Access Compliance Report Public Rights-of-Way (Curb Ramps)

Main Street: SPRING_VIEW_WAY	Cross Street: ROLLING_RIDGE	Location: SE
------------------------------	-----------------------------	--------------

ADA ID: RPRK211019140953	Ramp Type: Type 4 - Parallel	Initial Pass/Fail: Fail	Overall Compliance: No	Severity Score: 30
--------------------------	------------------------------	-------------------------	------------------------	--------------------

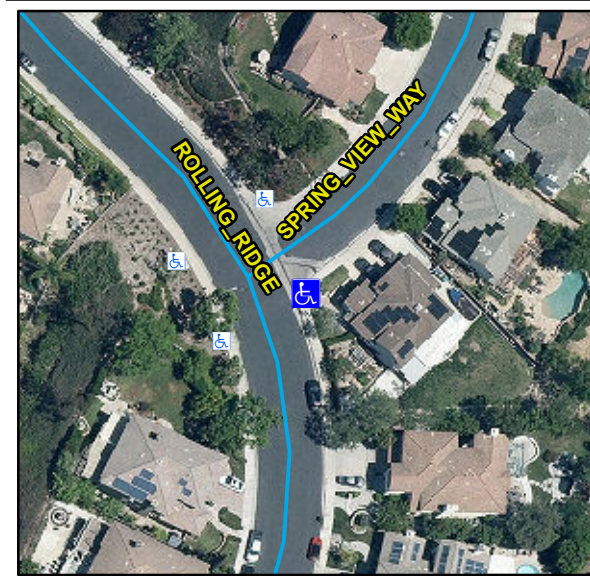
Compliance	Description	Data	Compliance	Description	Data
N/A	Ramp Length LT (in)	117	N/A	Ramp Length RT (in)	117
Yes	Ramp Width LT (in)	53	Yes	Ramp Width RT (in)	54
Yes	Ramp Run Slope LT (%)	1.3	Yes	Ramp Run Slope RT (%)	6.6
No	Ramp Cross Slope LT (%)	8.1	No	Ramp Cross Slope RT (%)	9.3
N/A	Landing Present	N/A	N/A	DWS Provided	N/A
N/A	Landing Length (in)	N/A	N/A	DWS Contrast	N/A
N/A	Landing Width (in)	N/A	N/A	DWS Length (in)	N/A
N/A	Landing Run Slope (%)	N/A	N/A	DWS Full Width	N/A
N/A	Landing Cross Slope (%)	N/A		DWS Offset Type	N/A
N/A	Landing Movement Obstructed?	N/A	N/A	DWS Offset Left (in)	N/A
	Landing Movement Type	N/A	N/A	DWS Offset Right (in)	N/A
N/A	Landing Shared	N/A			
N/A	Clear Space	Yes			
N/A	Clear Space To Crosswalk (in)	N/A			
N/A	Marked Crosswalk 1	No	N/A	Marked Crosswalk 2	No
	Crossing 1 Direction	N		Crossing 2 Direction	W
	Marked Crosswalk 1 Width (in)	N/A		Marked Crosswalk 2 Width (in)	N/A

N/A	Ramp Inside Crosswalk 1	N/A	N/A	Ramp Inside Crosswalk 2	N/A
	Crossing 1 Slope (%)	0.2		Crossing 2 Slope (%)	3.1
	Crossing 1 Cross Slope (%)	1.7		Crossing 2 Cross Slope (%)	4.2
N/A	Gutter Ponding	N/A	N/A	Curb Slope	6
No	Gutter Lip Height (in)	0.25		Road Run Slope (%)	2.9
N/A	Gutter Run Slope (%)	N/A		Road Cross Slope (%)	2.4
N/A	Gutter Cross Slope (%)	N/A	No	Perpendicular Joint Present	No
Yes	Overall Surface Condition	Acceptable			
	Cross Gutter Present?	Yes		Spandrel Present?	Yes
	Replace Cross Gutter?	No		Replace Spandrel?	No

Remove & Replace Curb Ramp With Two New Directional Ramps or Equivalent. Grind Gutter Lip.
